Safety Evaluation Report

related to the operation of
River Bend Station

Docket No. 50-458

Supplement No. 4 to the Safety Evaluation Report on the application filed by Gulf States Utilities Company as applicant and for itself and Cajun Electric Power Cooperative, as owners, for a license to operate River Bend Station has been prepared by the Office of Nuclear Reactor Regulation of the U.S. Nuclear Regulatory Commission. The facility is located in West Feliciana Parish, near St. Francisville, Louisiana. This supplement reports the status of certain items that had not been resolved at the time the Safety Evaluation Report and its first three supplements were published.

Figure 6.5 Wetwell temperature: Stuck-open relief valve, base case
Source: Licensee's letter of June 7, 1983, Figure 3

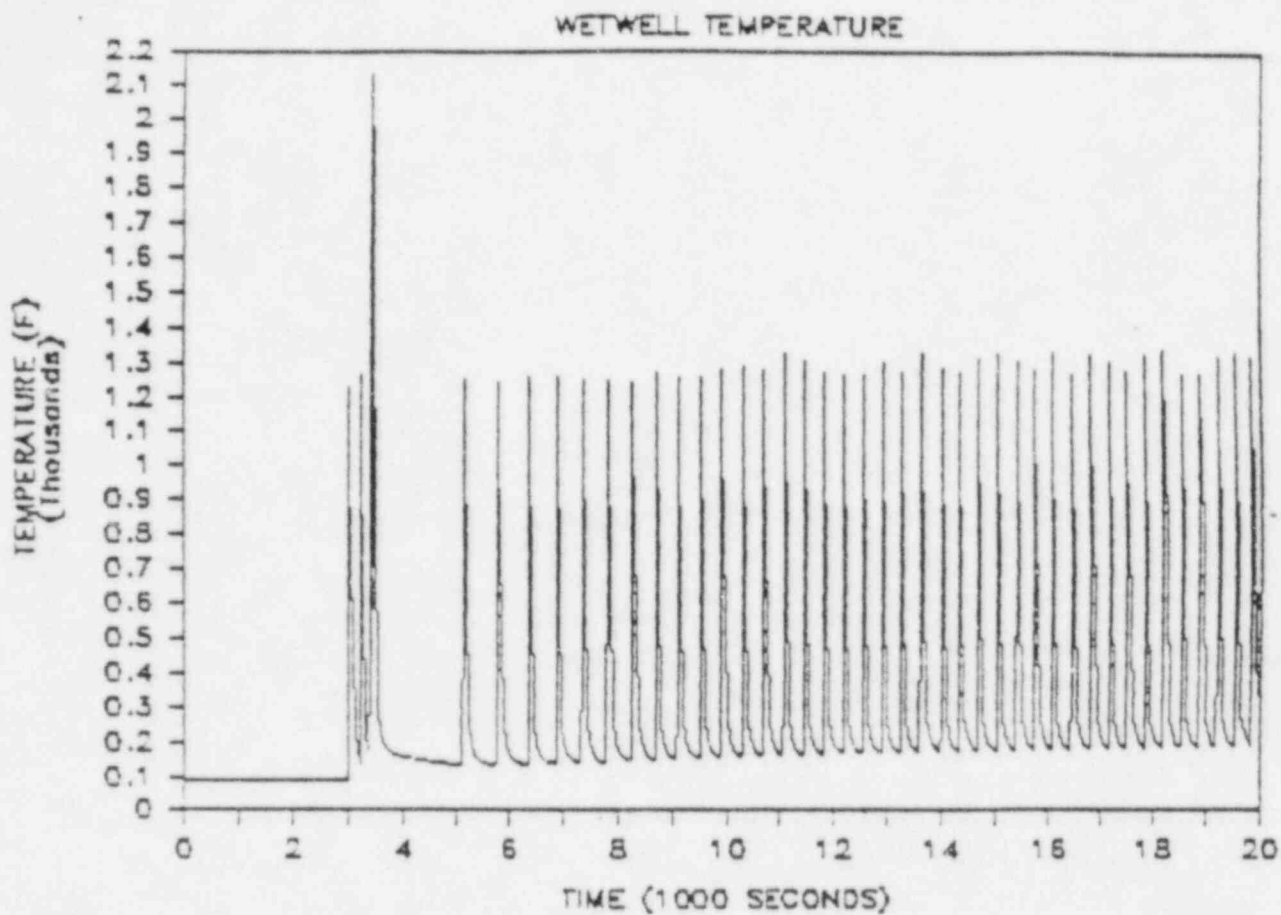
assumed to occur at 8% hydrogen concentration with a flame speed of 6 feet per second. The River Bend SORV base case produces a transient in which the hydrogen is ignited in a series of burns in the wetwell volume. The CLASIX-3 Code predicts a sequence of 42 wetwell burns (approximately 40 pounds of hydrogen per burn). Figures 6.5 and 6.6 show the wetwell temperature and pressure profiles. Referring to the wetwell temperature transient, the third burn resulted in the highest wetwell temperature (2135°F) for the entire transient; this burn is a consequence of the peak hydrogen release. Otherwise, the remaining wetwell burns produce a peak wetwell temperature of about 1300°F.

Figure 6.6 Wetwell pressure: Stuck-open relief valve, base case
Source: Licensee's letter of June 7, 1985, Figure 7

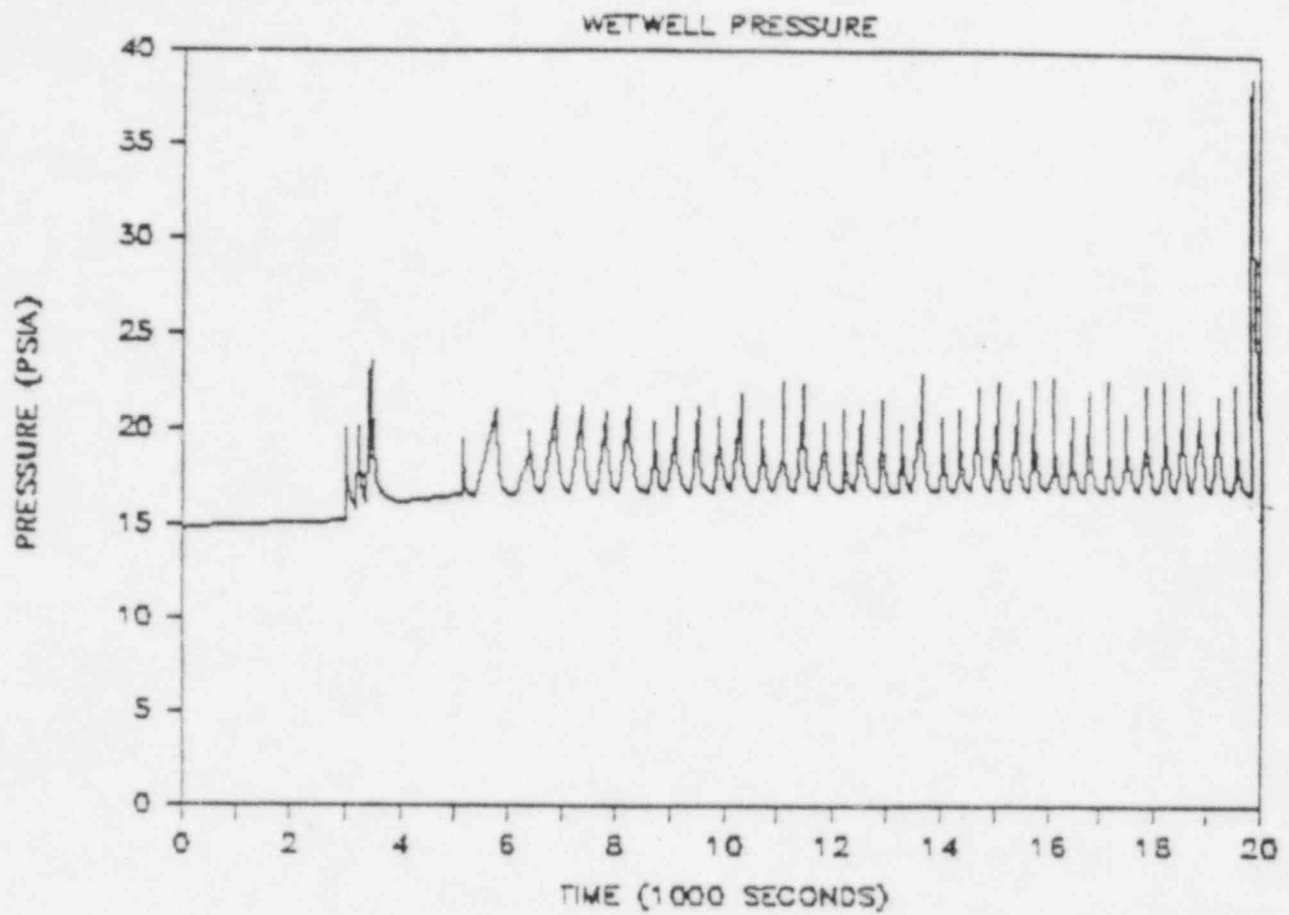
At the end of the hydrogen release period, the hydrogen concentration in the containment volume does not reach the ignition setpoint of 8%; the average concentration of hydrogen in the containment volume is about 6.5%. The licensee induced the only containment burn at the lower concentration and this resulted in the most severe pressure excursion to approximately 24 psig.

Figure 6.7 Wetwell temperature: Stuck-open relief valve, revised base case
Source: Licensee's letter of August 19, 1985, Figure 3

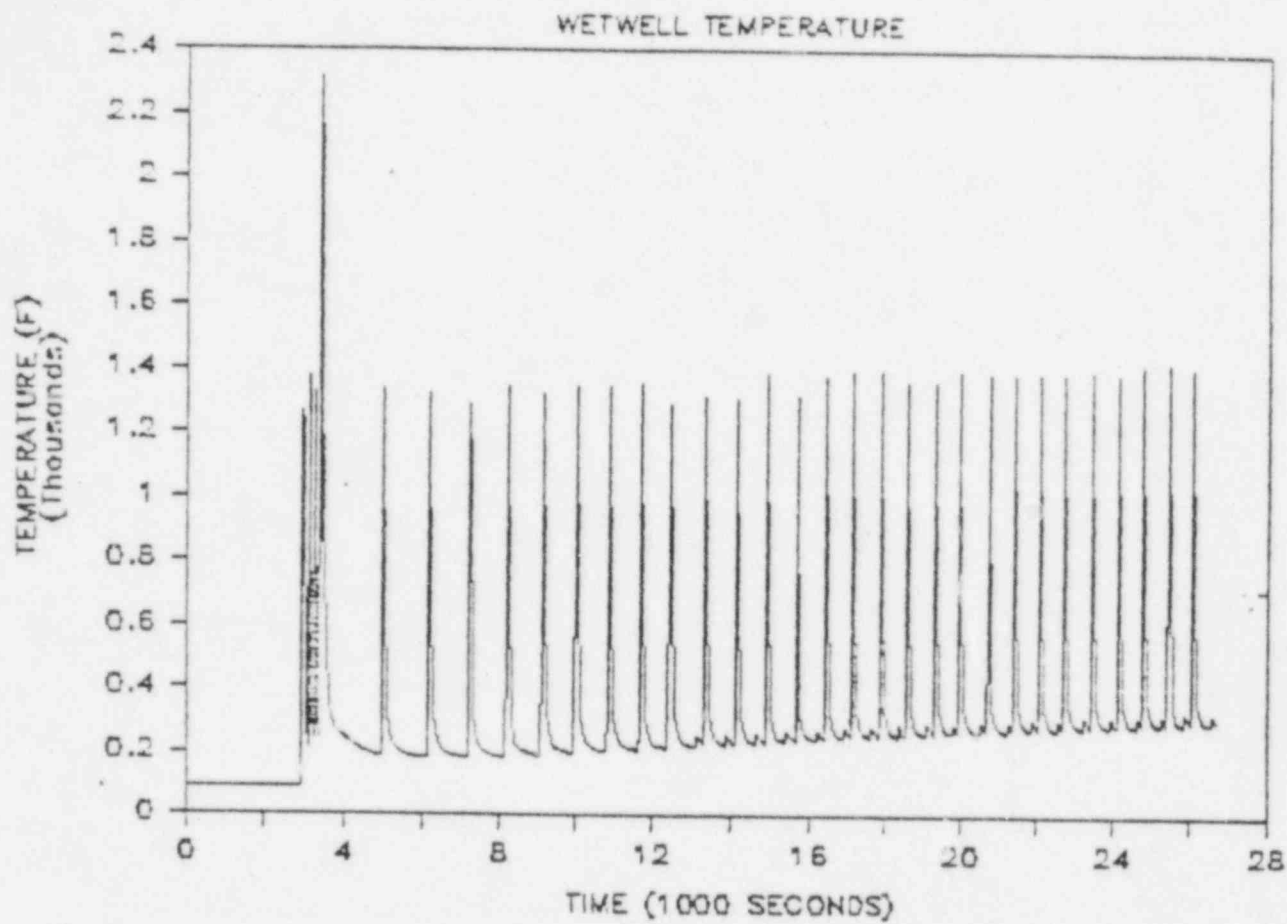
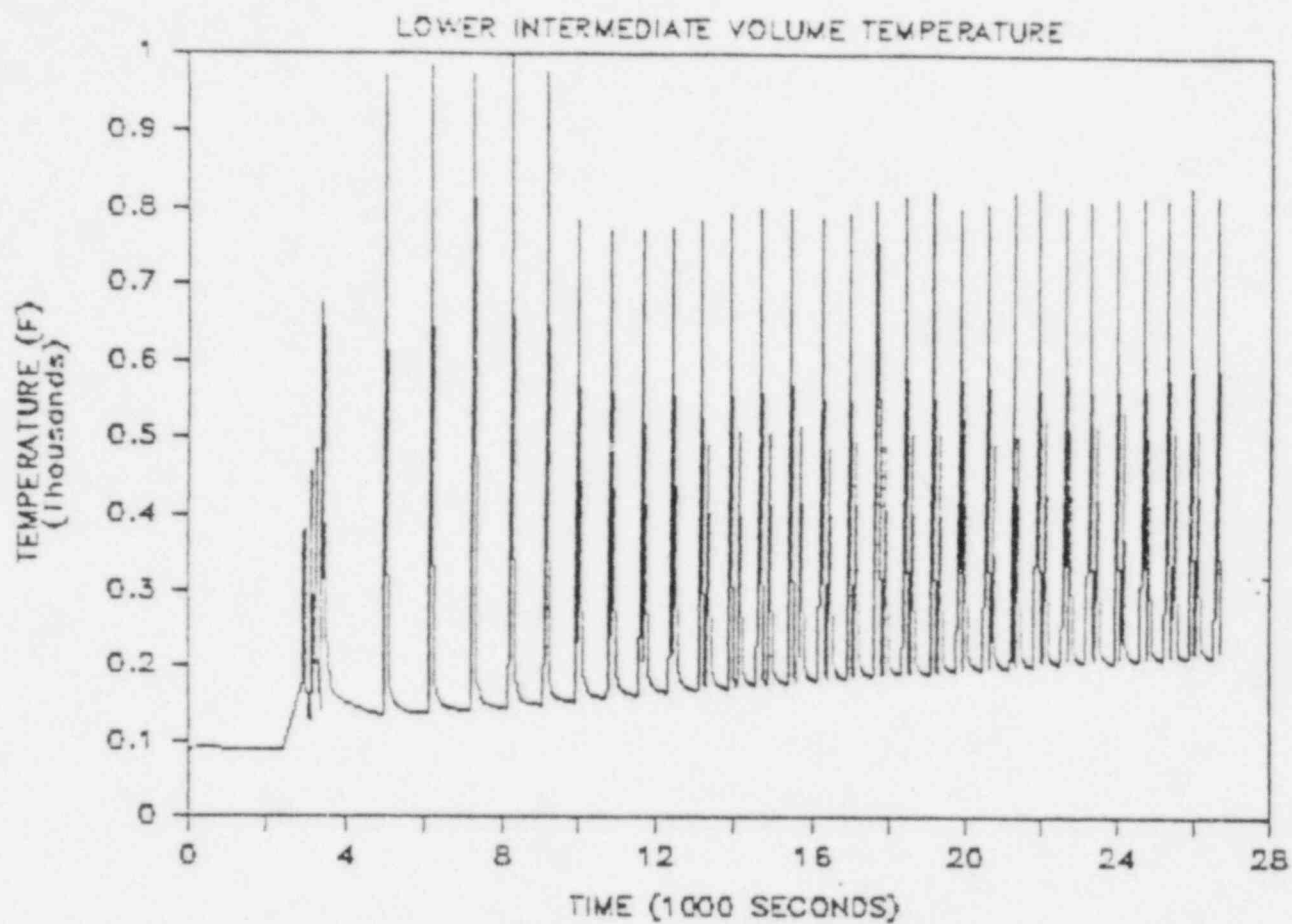
The revised River Bend SORV base case produces a transient in which the hydrogen is ignited in a series of burns confined to the wetwell volume (39 burns) and the lower intermediate volume (29 burns). Figures 6.7 and 6.8 show the respective volume temperature profiles.
